Agenda
Village of Arlington Heights
Design Commission
Virtual Meeting

August 11, 2020
6:30 PM

- A. DC#20-043 - 1161 N. Beverly Ln. - SF/Teardown
- B. DC#20-051 - 1215 N. Walnut Ave. - SF/Teardown
- C. DC#20-023 - Northwest Community Wellness Center - 900 W. Central Rd. / Sign Variation
- D. DC#20-049 - Driven Car Wash - 2100 S. Arlington Heights Rd. / Sign Variation

WEST ELEVATION

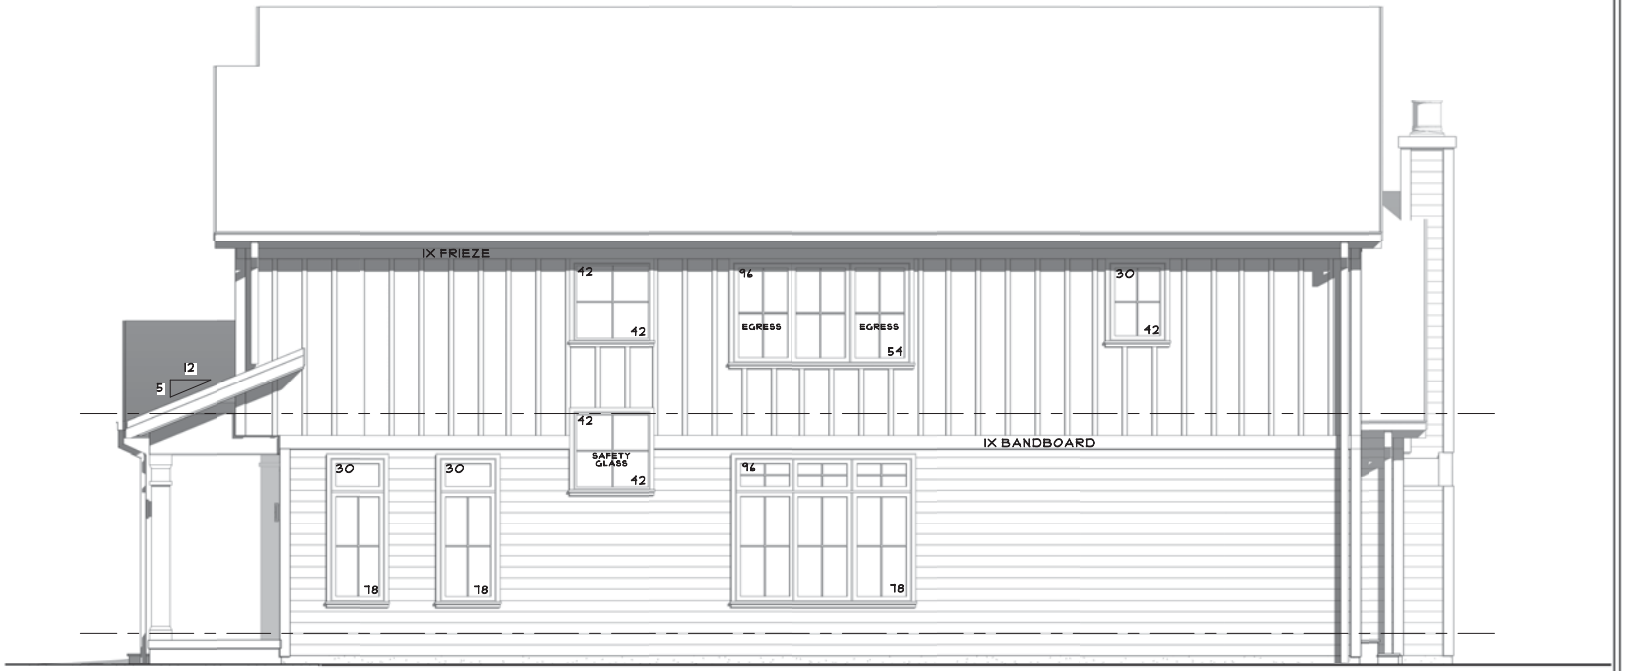
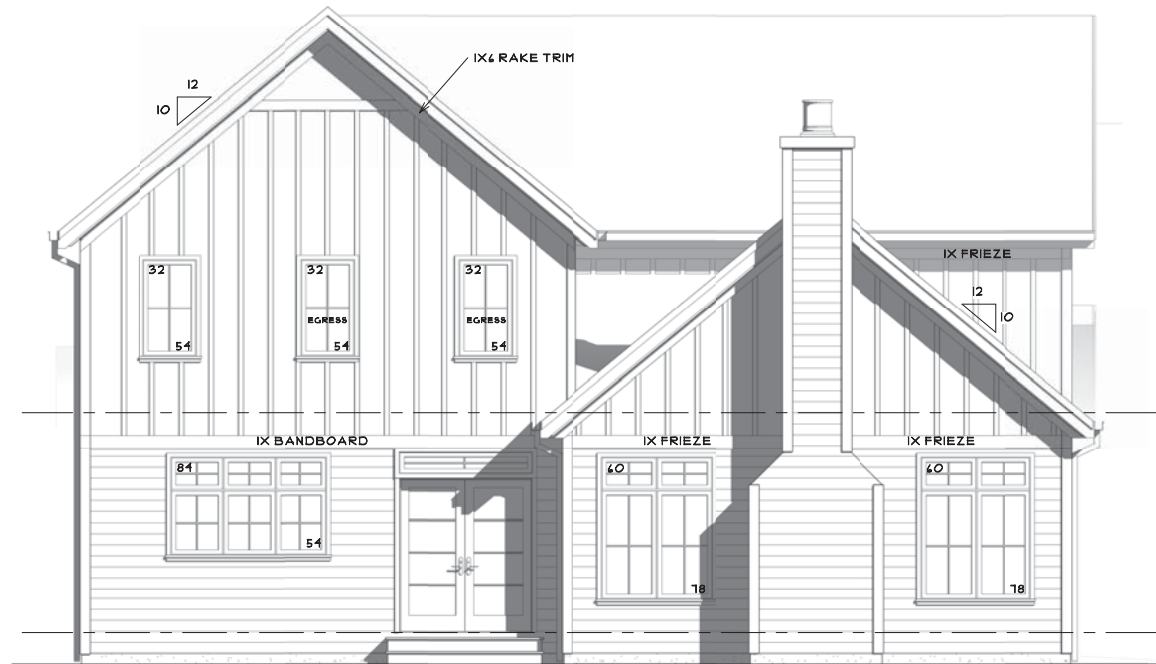
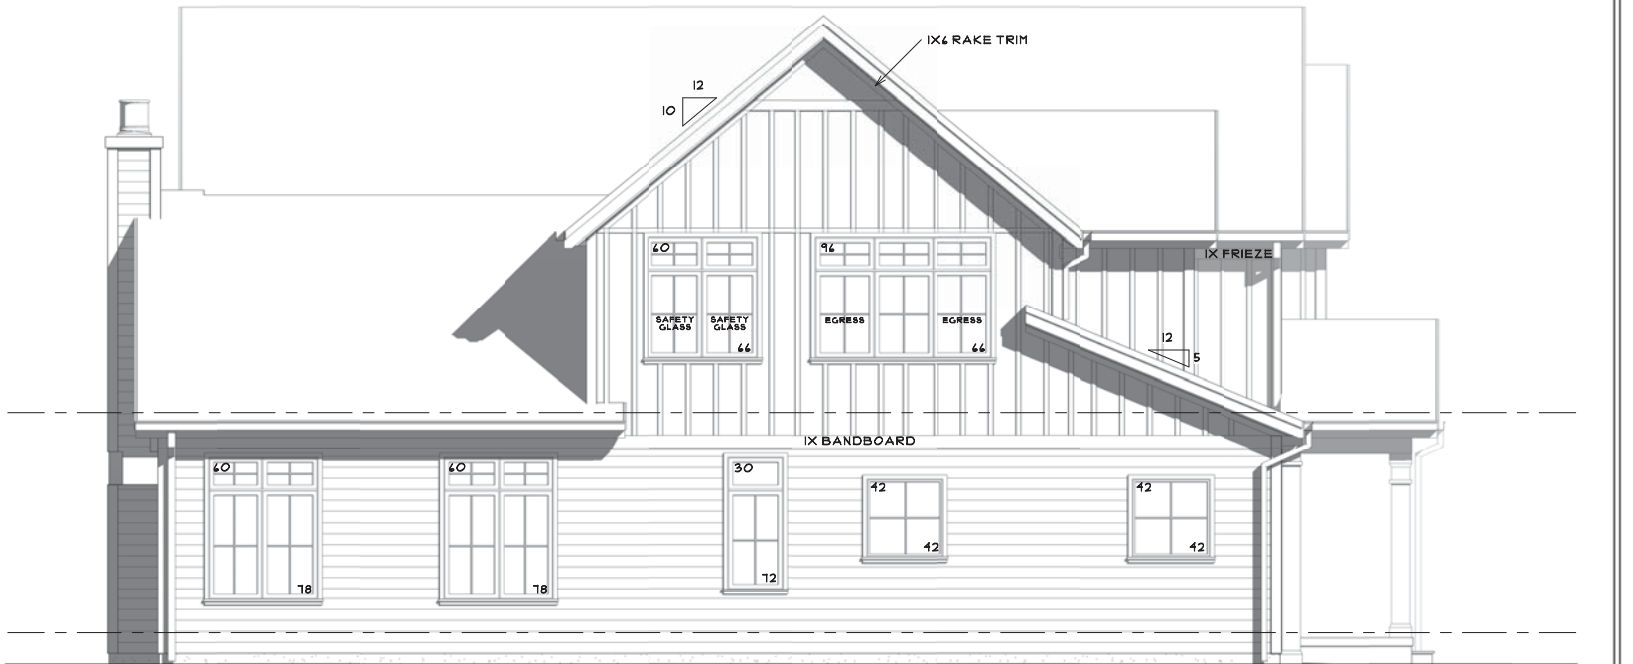
1. A recommendation to add some masonry accent to fit the character of the neighborhood.
2. A recommendation to consider a revised design with a detached garage.

1. A recommendation to add some masonry accent to fit the character of the neighborhood.
2. A recommendation to consider a revised design with a detached garage.

EAST ELEVATION

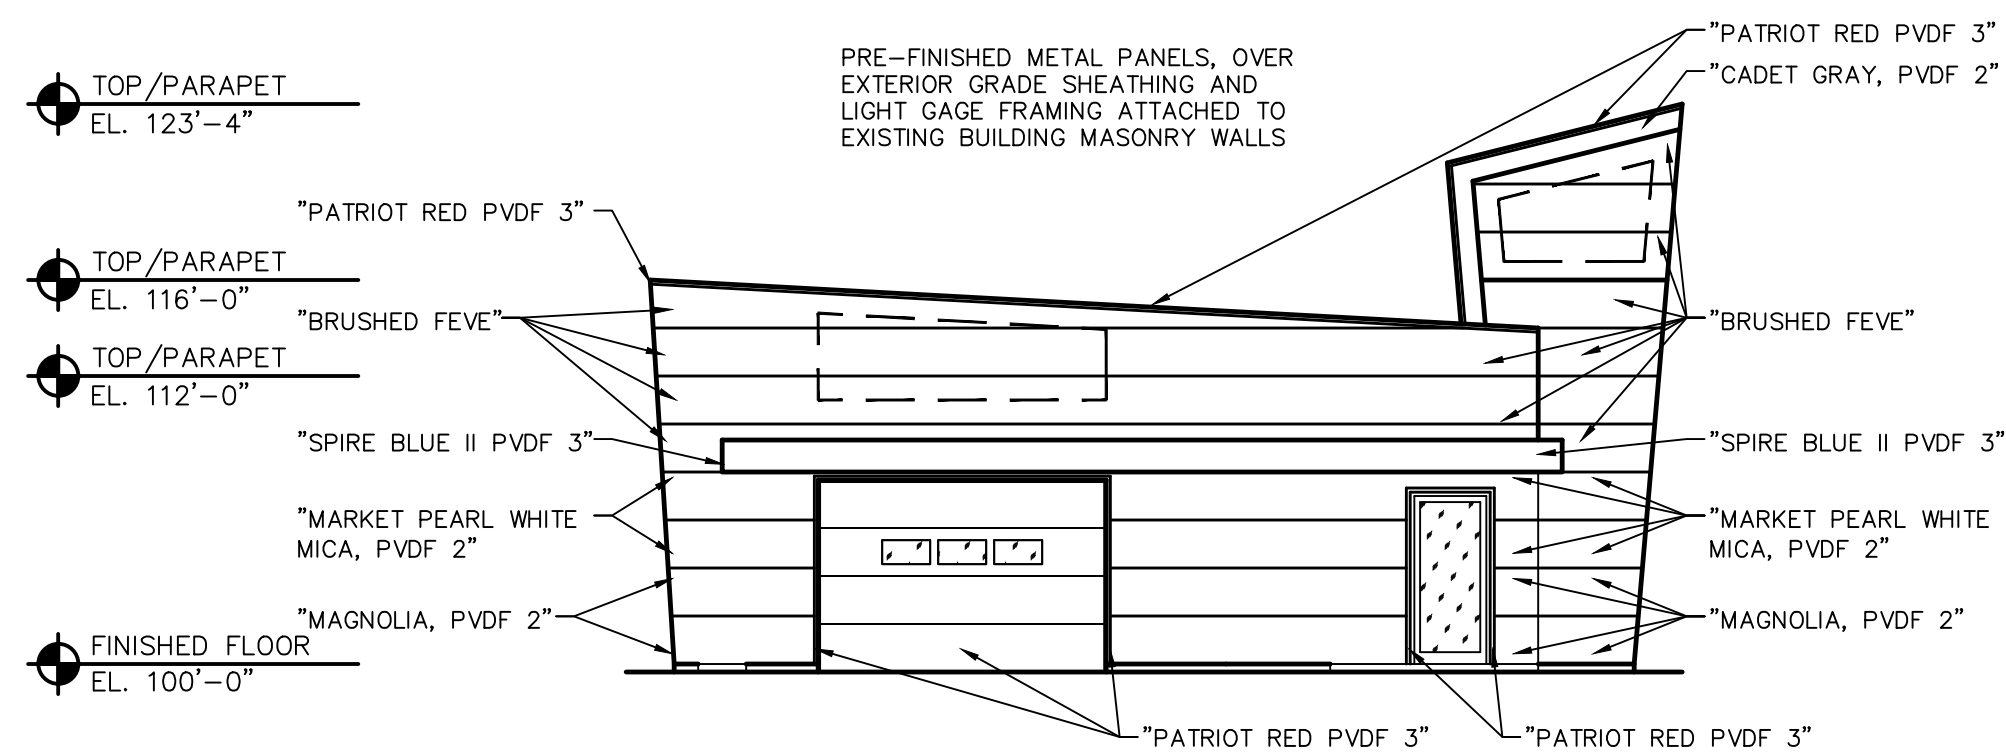
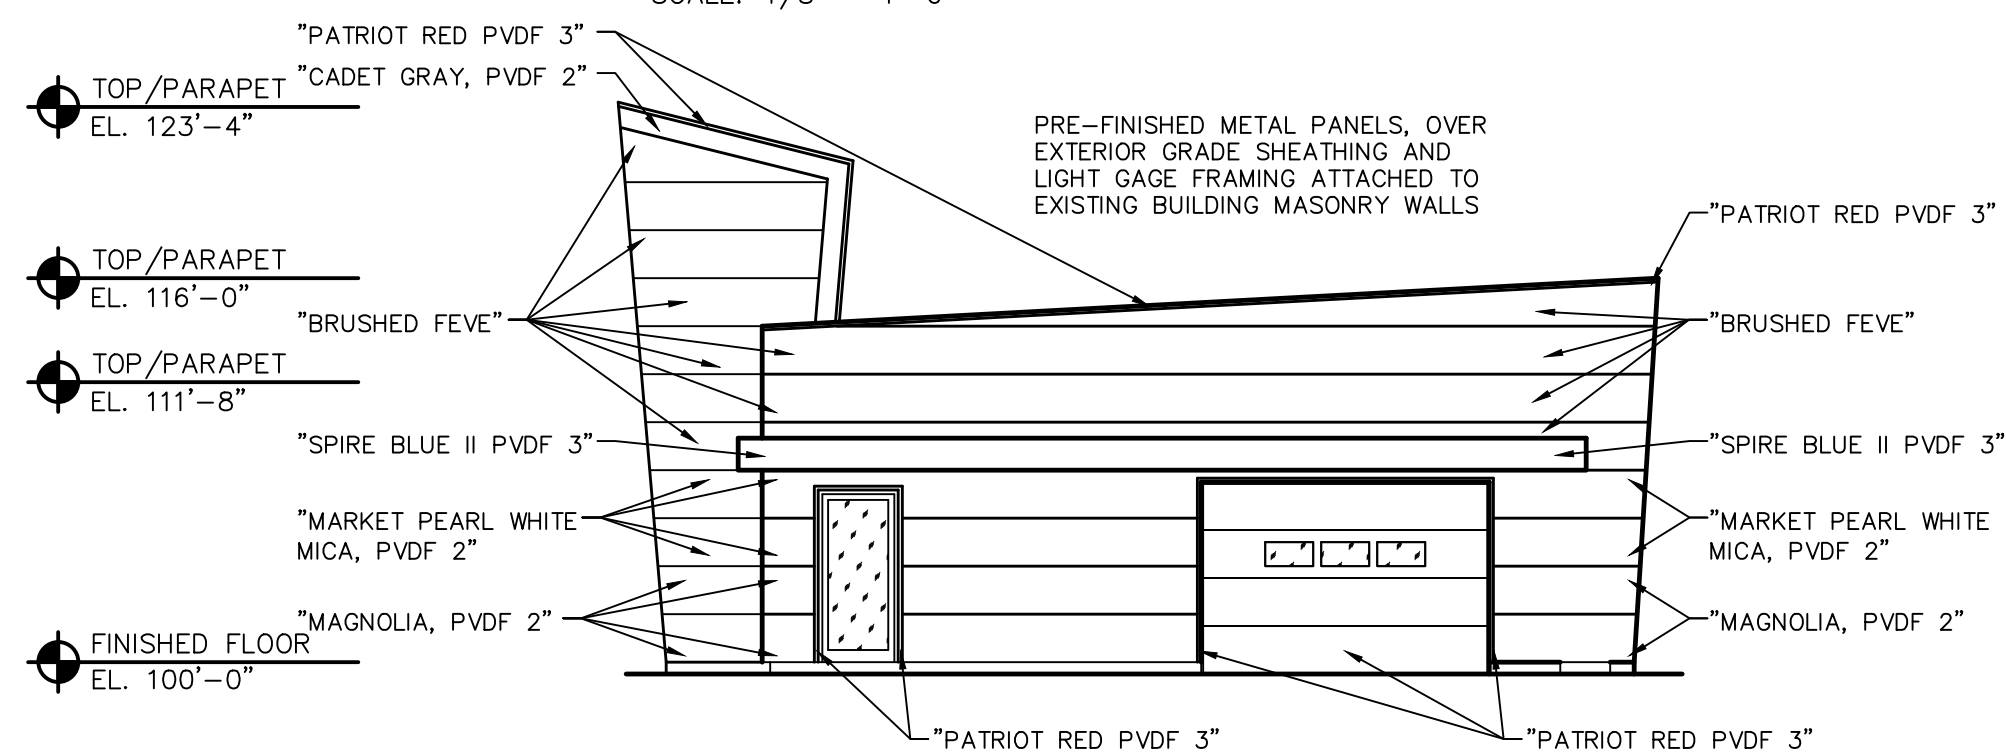
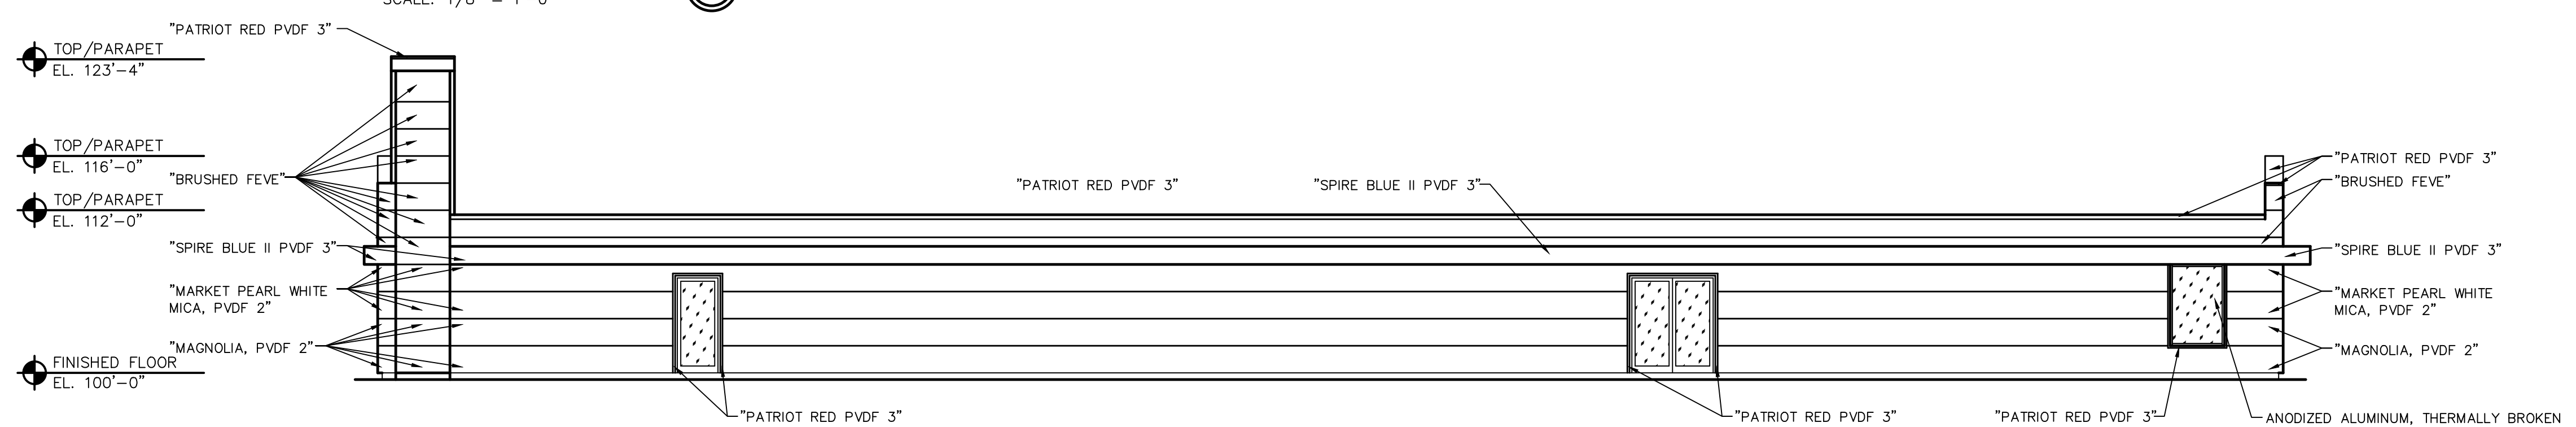
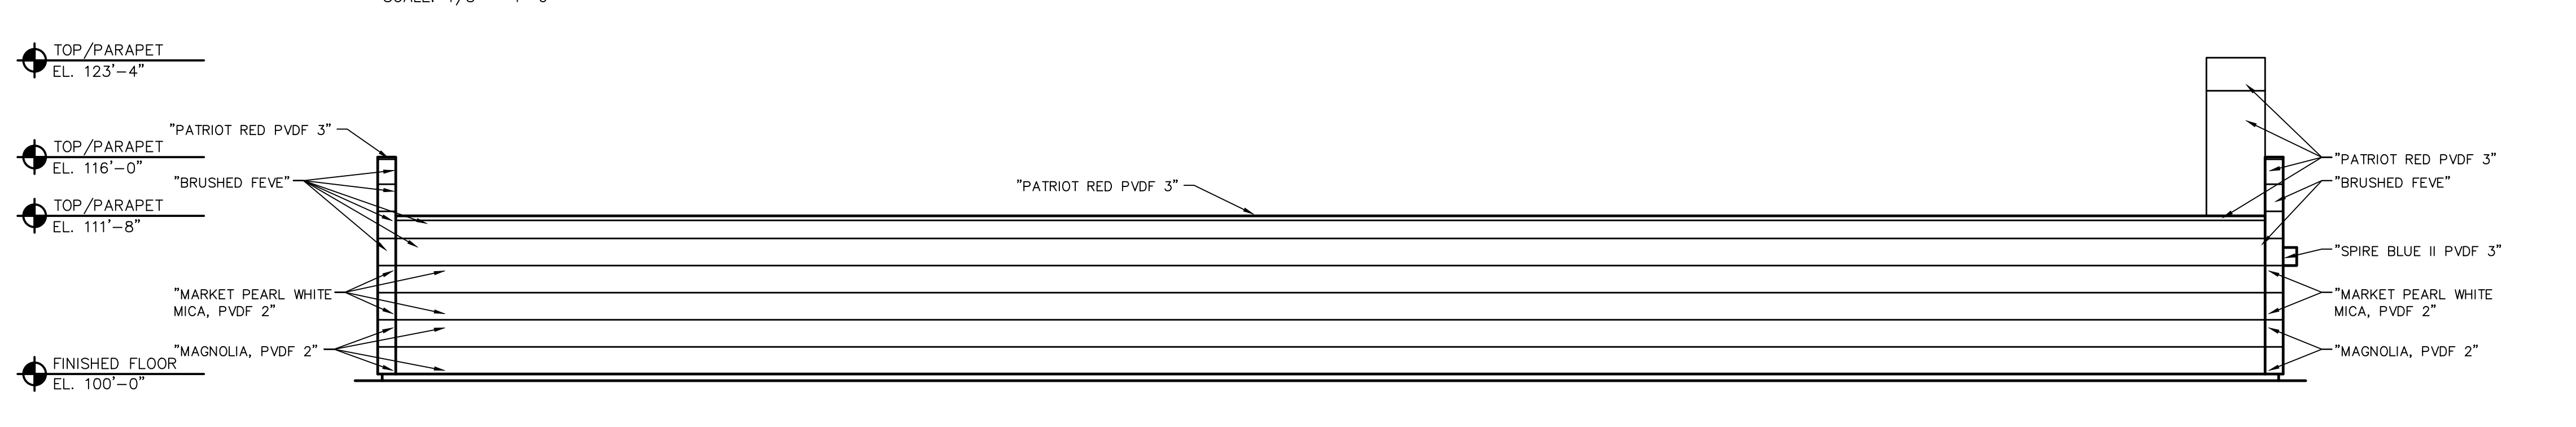
1. A variation from Chapter 30, section 30-402.a Number, to allow two wall signs on the east elevation, facing Arlington Heights Road, where only one wall sign is allowed.
2. A variation from Chapter 30, section 30-403.a Dimensions, to allow a second 20.25 sf wall sign on the east elevation, facing Arlington Heights Road, where 0 sf is allowed.

1. A requirement to replace the existing non-compliant ground sign with a new code-compliant decorative monument-style ground sign designed to complement the building design and branding.
2. This review deals with architectural design only and should not be construed to be an approval of, or to have any other impact on, any other zoning and/or land use issues or decisions that stem from zoning, building, signage or any other reviews. In addition to the normal technical review, permit drawings will be reviewed for consistency with the Design Commission and any other Commission or Board approval conditions. It is the architect/homeowner/builder's responsibility to comply with the Design Commission approval and ensure that building permit plans comply with all zoning code, building permit and signage requirements.
